E8361C-05A

S E R V I C E N O T E

E8361C PNA Microwave Network Analyzers

A new touchscreen display inverter shield is available to improve PNA noise floor performance.

Figure 3

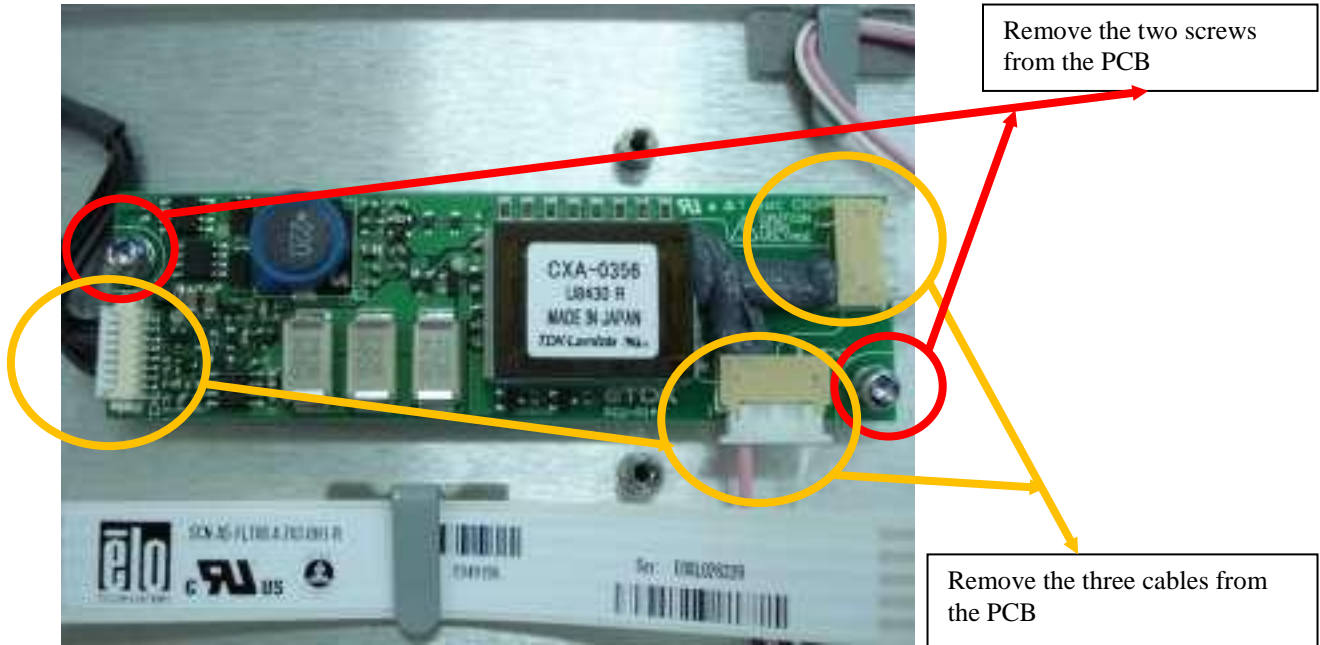
10. Remove the two screws from the PCB shown in Figure 3, using a T-10 wrench.
Disconnect the three cables connected to the PCB.
